ITEM: 6.6	REPORT SUMMARY MINOR VARIANCE APPLICATION FILE NUMBER A074/25
-----------	---

MINOR VARIANCE APPLICATION FILE NUMBER A074/25
---	---

CITY WARD #:	3
APPLICANT:	Tanya Prefontaine & Michael Noel Prefontaine
AGENT:	Tanya Prefontaine
PROPERTY:	127 Antorisa Avenue, Woodbridge
ZONING DESIGNATION:	See below.
VAUGHAN OFFICIAL PLAN (2010) DESIGNATION:	Vaughan Official Plan 2010 ('VOP 2010'): "Low Rise Residential"
RELATED DEVELOPMENT APPLICATIONS:	N/A
PURPOSE OF APPLICATION:	Relief from the Zoning By-law is requested to permit the placement of an outdoor swimming pool with reduced setbacks to the rear and side lot lines, a wall-mounted air conditioner with increased encroachment into the side yard, a BBQ station with a reduced side yard setback, and a trellis located on the lot line.

Trellis Detail

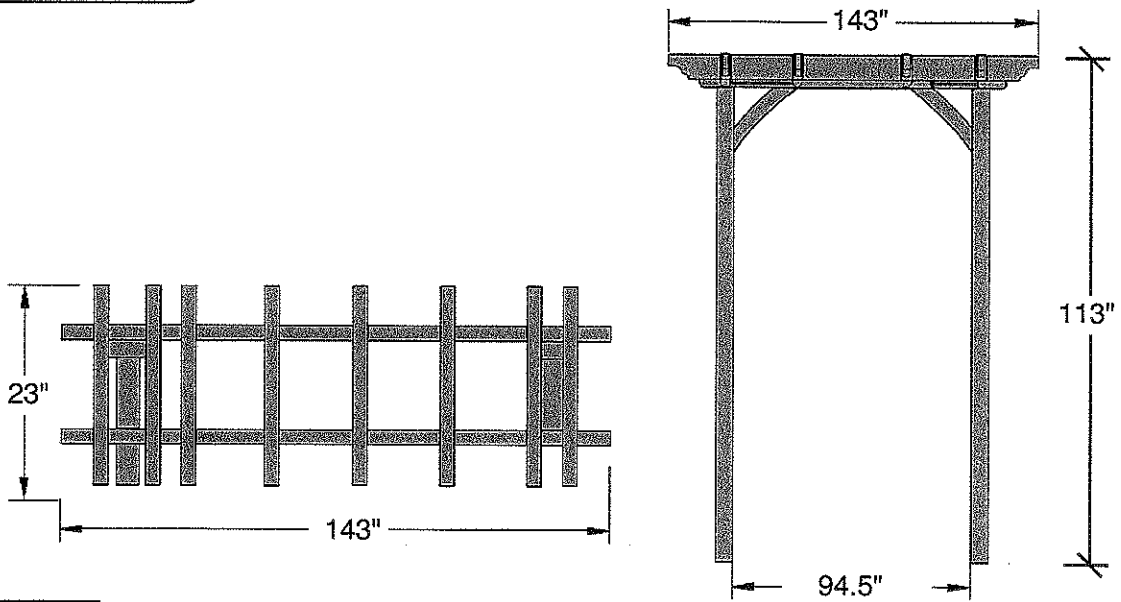
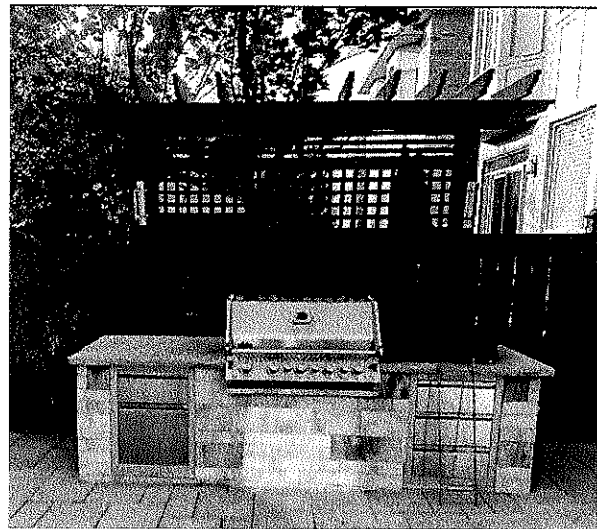
0.0 m setback
distance from top of
trellis to property line

Portion of top of
trellis to be removed
to provide 0.15 m
setback distance to
property line

neighbour. The proposed trellis is located between the BBQ island and the northern interior side lot line. The proposed trellis is 2.87 m in height and is supported by two wood columns. The proposed trellis has an open and minimal mass and is not anticipated to incur visual impacts on the adjacent property. Development Engineering staff have reviewed the proposed setback reductions and have no concerns regarding their impacts on stormwater runoff.
